# HISTORIC AND DESIGN REVIEW COMMISSION

October 21, 2015 Agenda Item No: 29

HDRC CASE NO:	2015-422
ADDRESS:	247 E KINGS HWY
LEGAL DESCRIPTION:	NCB 6327 BLK 2 LOT 41, E 3 FT OF 40 & W 2 FT OF 42
ZONING:	R5 H
CITY COUNCIL DIST.:	1
DISTRICT:	Monte Vista Historic District
<b>APPLICANT:</b>	Macario Rosas/VR Construction
OWNER:	Mike Hollaway/Mike Hollaway Custom Homes
TYPE OF WORK:	Amend COA to Account for Tree Preservation and New Driveway

The applicant is requesting to amend a Certificate of Appropriateness issued on June 18th, 2014, to change the location and width of the driveway, approach and sidewalk.

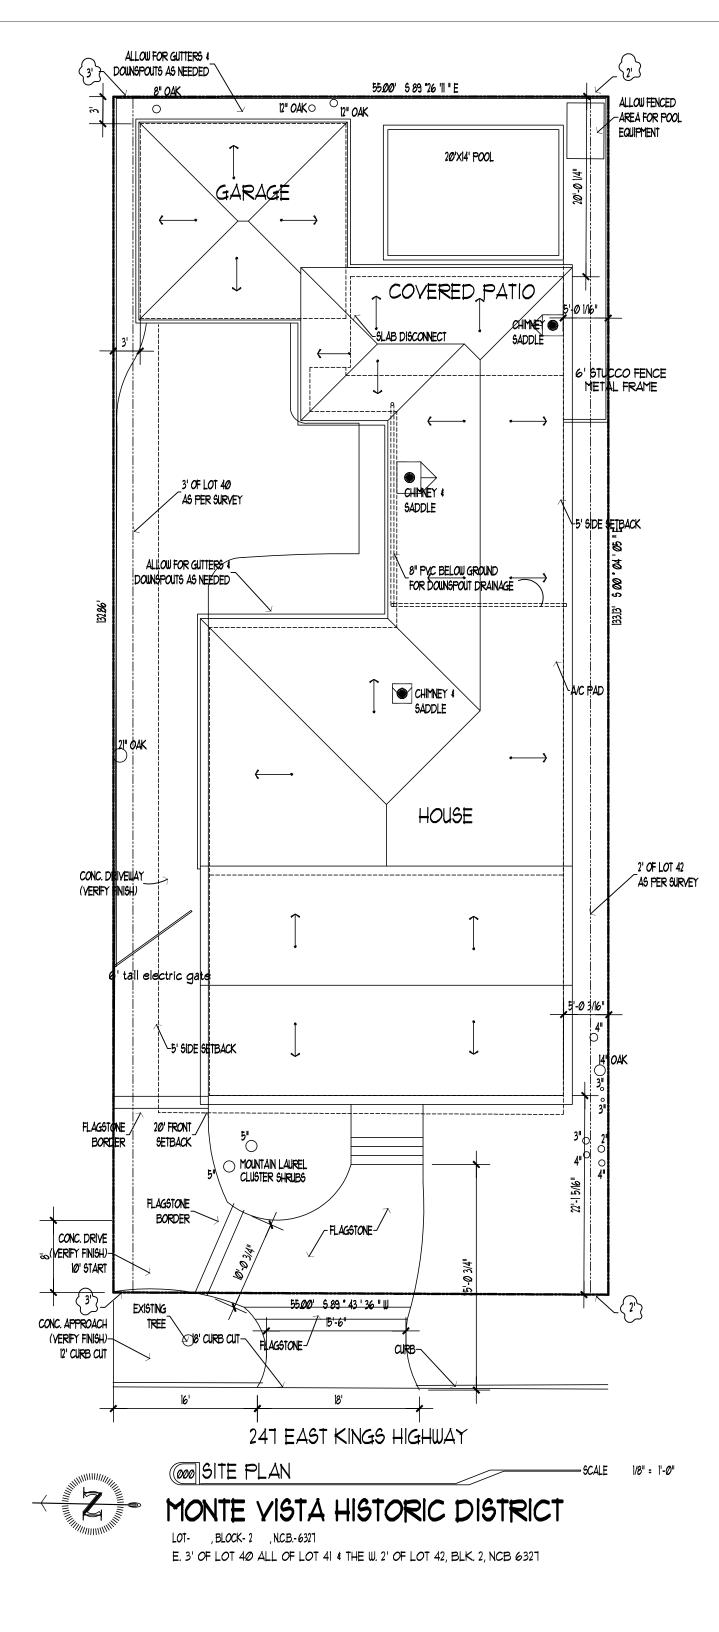
- b. The City Arborist has recommended that a tree in the right of way, in the location of the approved apron, should be preserved and not removed.
- c. In order to preserve the tree, the applicant has proposed to move the drive way and apron to the center of the lot and increase the width to 18' feet. The drive and approach would be in front of the main structure, which is not typical in Monte Vista. The Guidelines for Site Elements 5, B, i. state that historic driveways should be no wider than 10 feet. The proposed width for the driveway and approach are not consistent with the guidelines. Staff recommends that the driveway be no wider than 10 feet and the curb cut no wider than 12 feet

- d. The revised site plan proposed an increase to the amount of hardscaping in the front yard of the property. The Guidelines for Site Elements 3, A, ii., state that historic lawn areas should never be reduced by more than 50%. The proposed hardscaping is not consistent with the guidelines.

Staff does not recommend approval based on findings a through d. Staff recommends that the applicant develop a site plan that includes a linear driveway no wider than 10 feet with a curb cut no wider than 12 feet. A curved option may be appropriate to avoid the significant tree.
